Evaluation of Physical Barriers – Pedley Station

Address: 6001 Pedley Rd, Riverside, CA 92509

Evaluation Date: 08-05-2021

RCTC ADA Self-Evaluation and Transition Plan - Attachment 6E

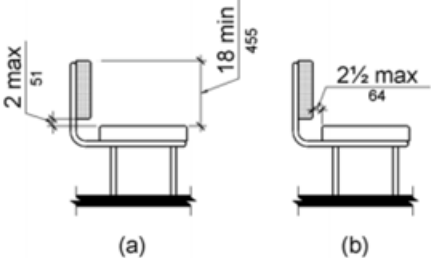
<p>Trails in the landscaped areas at the bus stops are not accessible. No accessible route leads to them and the walking path surface is not firm.</p> 	<p>If the park is not open for public use either, add signage prohibiting public access.</p>
